Our data suggests that the surface waters and bottom sediments in streams and lakes at the Great Bear Gold Project site may have been exposed to toxic elements during the exploration drilling activities at the site. Thus, the proponent baseline surface water quality program done at site, as described in the Detailed Project Description of January 2024 done at site (p 43) is probably flawed.

We conclude that in the EIS Directive to the proponent, IAAC must insist that water quality baseline work for the Great Bear Gold project be done outside of the zone of past exploratory drilling.

Fig 3

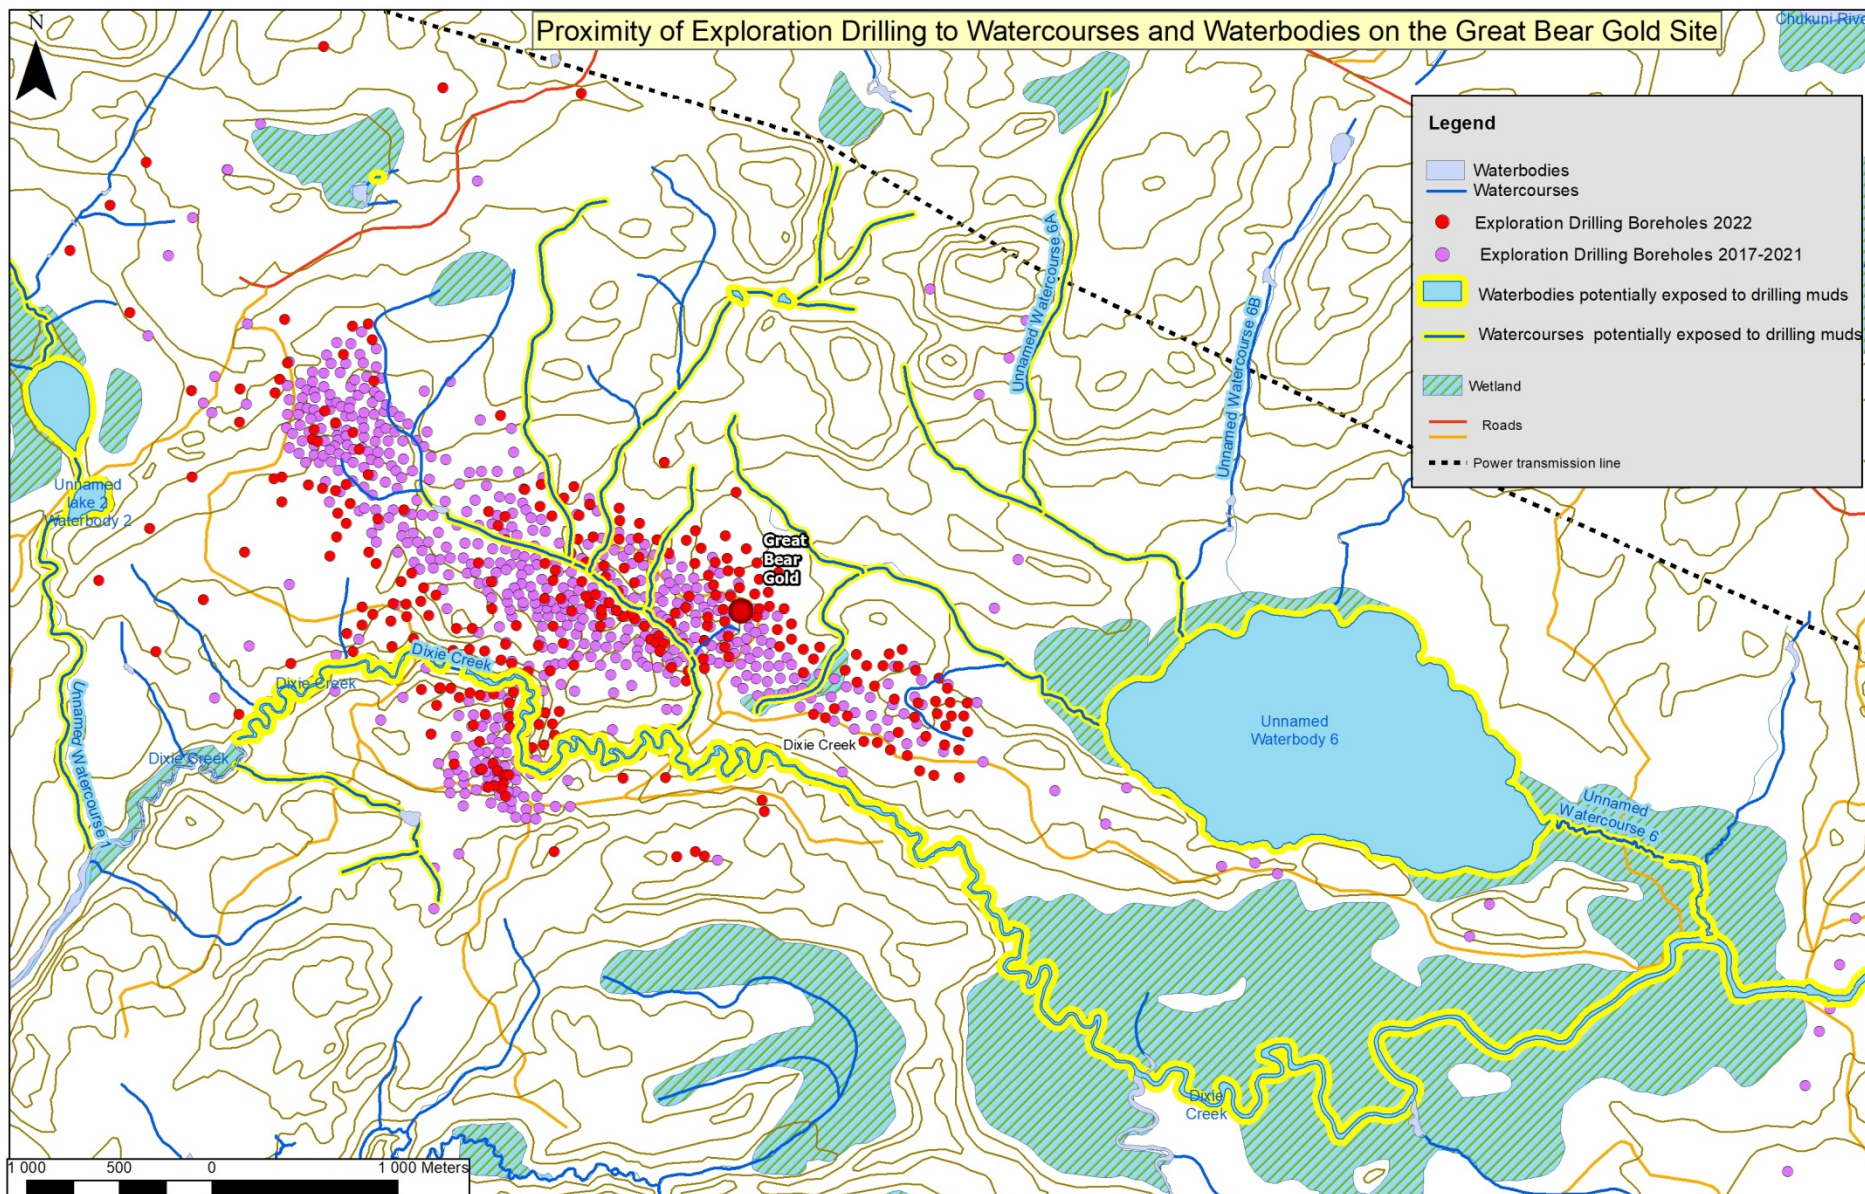
We have taken borehole collar location information from maps and tables in Kinross NI 43-101 Technical Report of February 2023 and have generated a layer map (ARC GIS) with watercourses and waterbodies at the Great Bear site. This map (Figure 3) identifies streams and lakes most likely to have been exposed to mobilized drilling muds at the site.

The Unnamed waterbody 1, Unnamed waterbody 6 and Dixie Creek sampled during this program have all been exposed to the drilling muds as our mapping suggests. Thus the concentrations greater than established by water quality guidelines observed by Kinross are not “naturally occurring” but are more likely the product of drilling mud contamination.
